**POLICY ISSUE**  
(Notation Vote)

SECY-07-0112

SUBJECT: STAFF EVALUATION AND PROPOSED REVISION TO THE PUBLIC RADIATION SAFETY SIGNIFICANCE DETERMINATION PROCESS TO ADDRESS RADIOACTIVE LIQUID SPILLS AND LEAKS

**Excerpt from Inspection Manual Chapter 0609, Appendix D  
Public Radiation Safety Significance Determination Process**

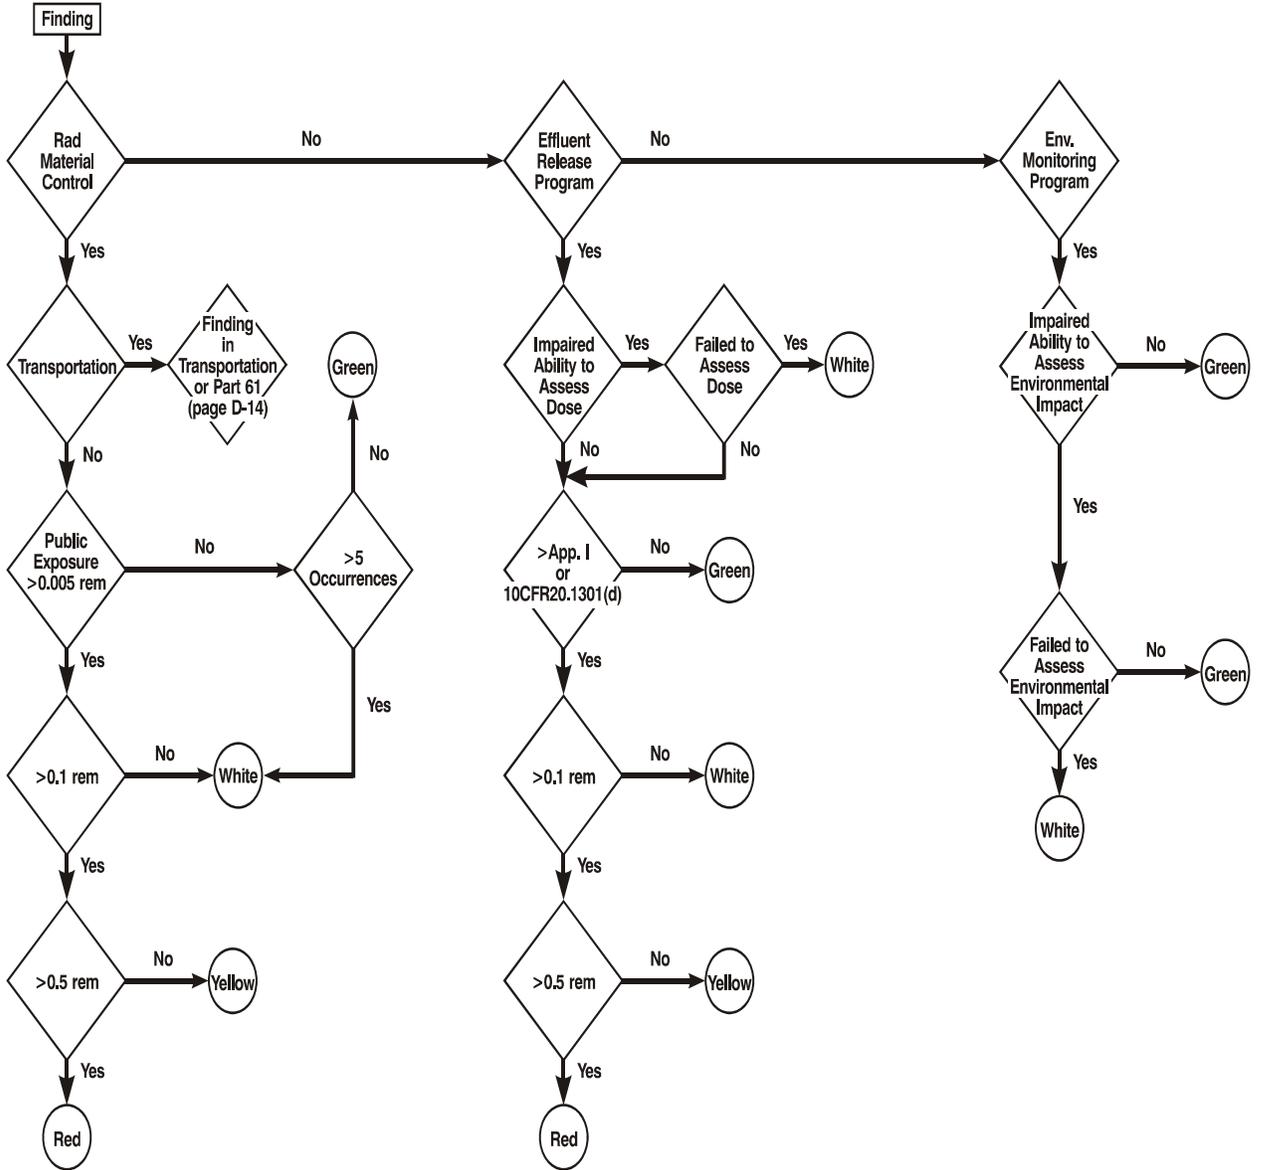
The staff also evaluated the potential for confusion associated with the "Impaired Ability to Assess Dose" loop in the radioactive effluent release program branch of the SDP (Enclosure 1). The staff's evaluation concluded that the loop created confusion for many stakeholders, including licensees and inspectors. The staff, with stakeholder input, also recommends removing the distinction between a licensee having an impaired ability to assess dose and failing to assess dose (Enclosure 3).

The staff evaluated the clarity of the entry conditions into the two branches (radioactive effluent release program branch and radioactive environmental monitoring program branch) of the Public Radiation Safety SDP (Enclosure 1). During the staff's assessment of the Braidwood event, it appeared that both of these branches of the SDP would apply. The staff concluded that the current Public Radiation Safety SDP should be modified: (1) to clarify entry into the radioactive effluent release program branch of the current SDP; and (2) to determine a threshold to address spills and leaks.

The staff concluded that the radioactive effluent release program branch of the SDP should be revised to specifically include spills and leaks under this program by adding a new criterion for a substantial failure to implement the radioactive effluent release program (Enclosure 3). The criteria for a failure to implement the program is a loss of effluent controls to an extent such that: (1) a substantial potential existed for exceeding the public ALARA dose criteria, but fortuitous events prevented the dose from exceeding ALARA thresholds; or (2) the licensee was negligent in identifying and evaluating the event. A finding for spills and leaks would be evaluated in a similar manner to planned effluent discharges, such that a failure to implement the program would encompass a finding for a failure to assess dose. The significance of this event would be classified as low significance (White finding).

2. The radioactive effluent release program branch and radioactive environmental monitoring program branch will remain in the SDP; and the radioactive effluent release program branch will be modified to specifically include spills and leaks as unplanned effluent releases.

**Excerpt from Inspection Manual Chapter 0308, Attachment 3, Appendix D**  
**Technical Basis for Public Radiation Safety Significance Determination Process**

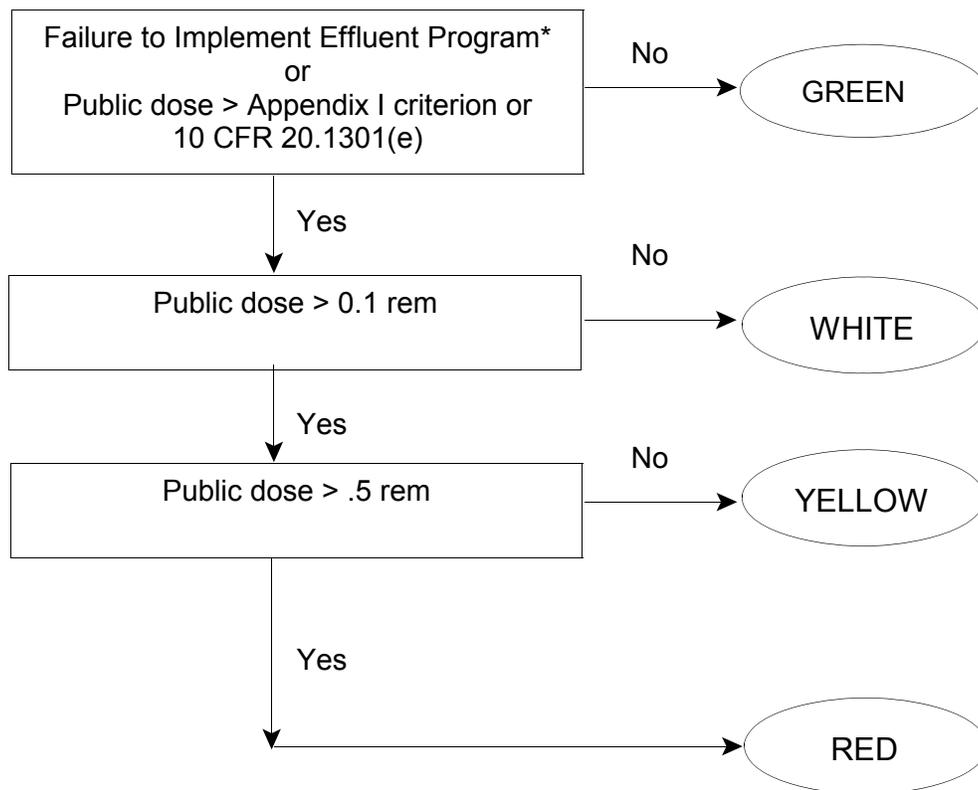
The staff evaluated the radioactive environmental monitoring program branch of the Public Radiation Safety SDP (Enclosure 1) and found that the criteria for a White finding is not consistent with the risk-informed goals of the ROP. The staff concluded that the radioactive environmental monitoring program branch would be better aligned with the risk-informed goals of the ROP by reducing the significance of a licensee's failure to assess the environmental impacts to very low significance (Green finding). This recommendation is based on the consideration that the radioactive effluent release program is functioning properly, and has prevented significant public dose. Thus, the radioactive environmental monitoring program is a verification process, and findings that are greater than very low significance would be captured by the radioactive effluent release program branch. The staff recommends modifying the radioactive environmental monitoring program branch of the SDP as shown in Enclosure 3.

3. The criteria for a White finding should be removed from the radioactive environmental monitoring program branch, since the significance of a performance deficiency identified by this branch will be evaluated by the effluent release program branch.
